Product/Process Change Notice (PCN)

PCN Number: PCN_WCAP-CSSA_20250207 Affected Series: WCAP-CSSA Affected Part Number: See table below PCN Date: 2024-11-07 (YYYY-MM-DD) Effective Date: 2025-02-07 (YYYY-MM-DD)	Change Category: <input type="checkbox"/> Equipment/Location <input checked="" type="checkbox"/> General Data <input type="checkbox"/> Material <input type="checkbox"/> Process <input type="checkbox"/> Product Design <input type="checkbox"/> Shipping/Packaging <input type="checkbox"/> Supplier <input type="checkbox"/> Software
Contact: Product Management Phone: +49 (0) 7942 - 945 5001 Fax: +49 (0) 7942 - 945 5179 E-Mail: pcn.eisos@we-online.com	Datasheet Change: <input checked="" type="checkbox"/> Yes <input type="checkbox"/> No Attachment: <input type="checkbox"/> Yes <input type="checkbox"/> No

To meet current customer demands, Würth Elektronik eiSos will update the dimension of 9 part numbers of WCAP-CSSA series. And because of a database mismatch, Würth Elektronik eiSos will correct the datasheets for 23 part numbers of WCAP-CSSA series.

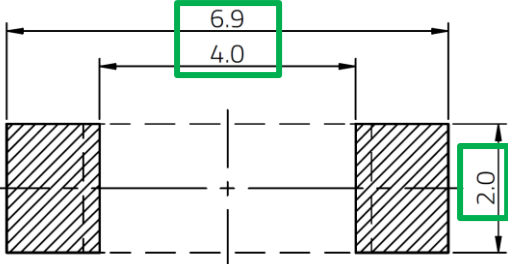
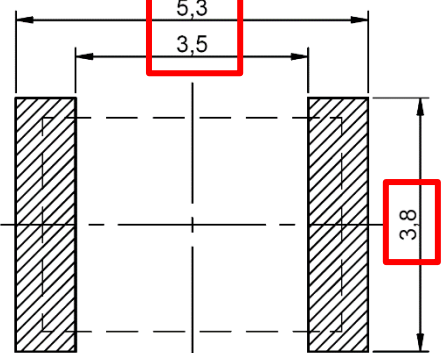
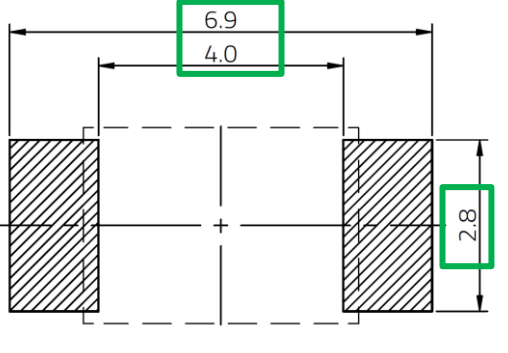
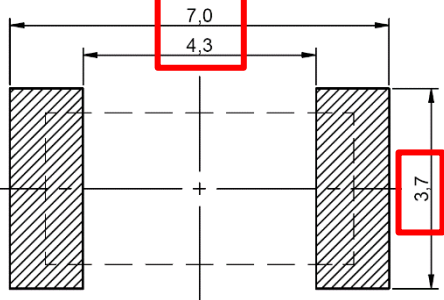
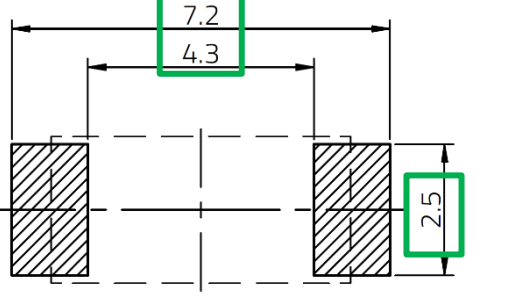
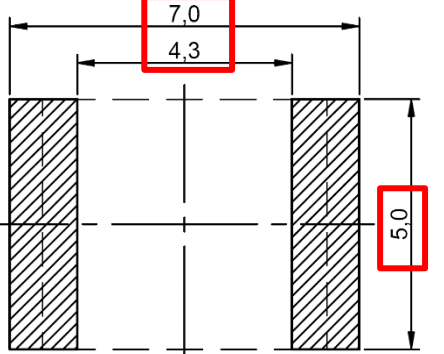
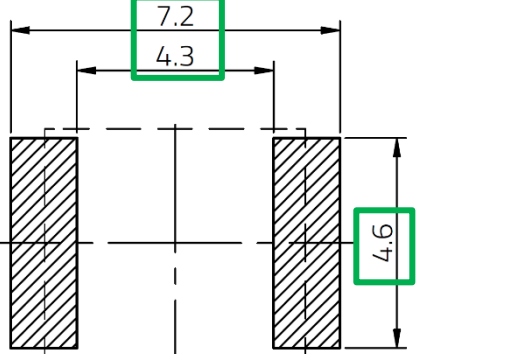
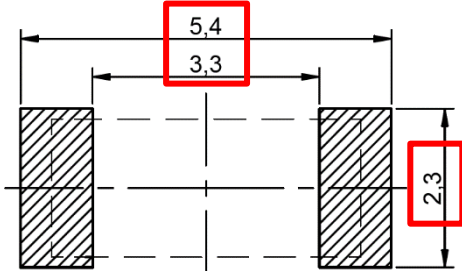
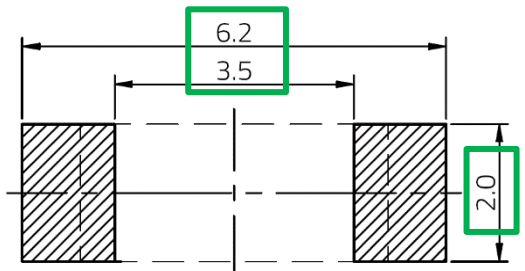
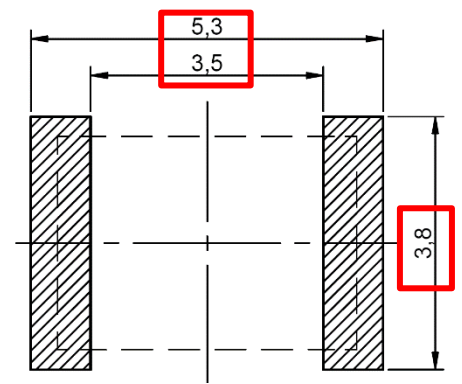
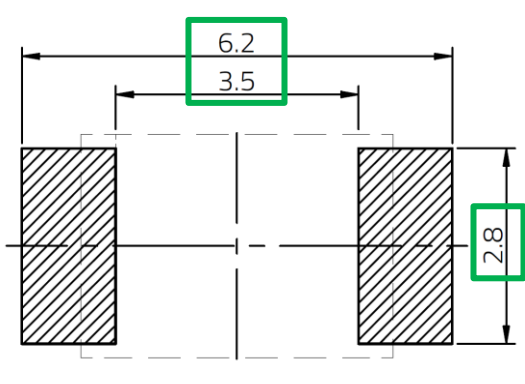
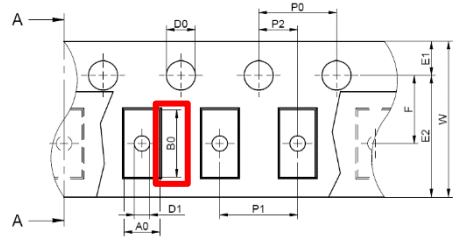
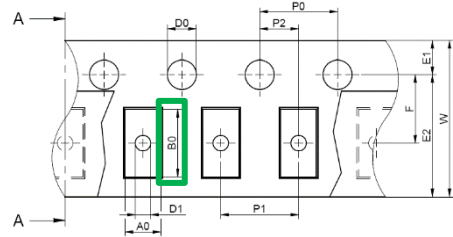
- Correction of the dimension specification. Corrected dimensions and tolerances are marked with a red box before change and green box after change.

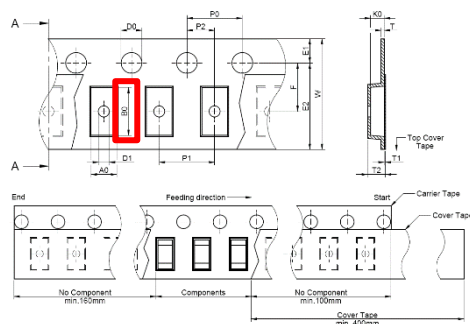
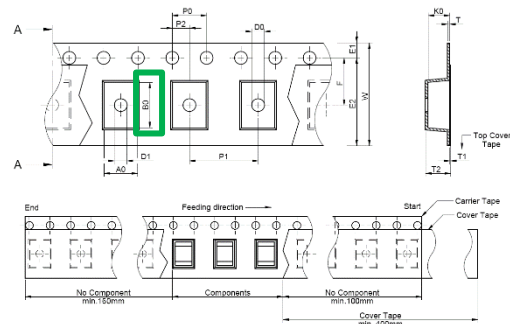
2. Correction of the Recommended Land Pattern specification. Corrected specifications are marked with a red box **before change** and green box **after change**.

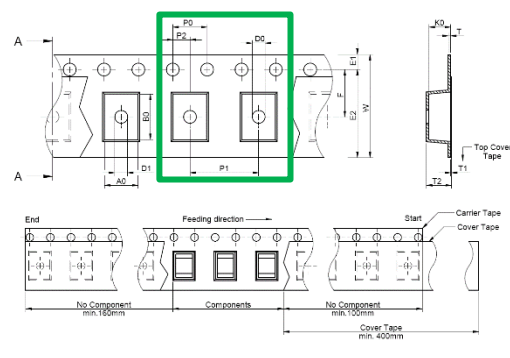
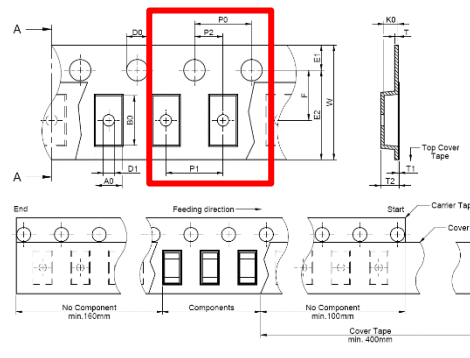
4. Correction of the packaging drawing. Corrected drawing is marked with a red box before change and green box after change.
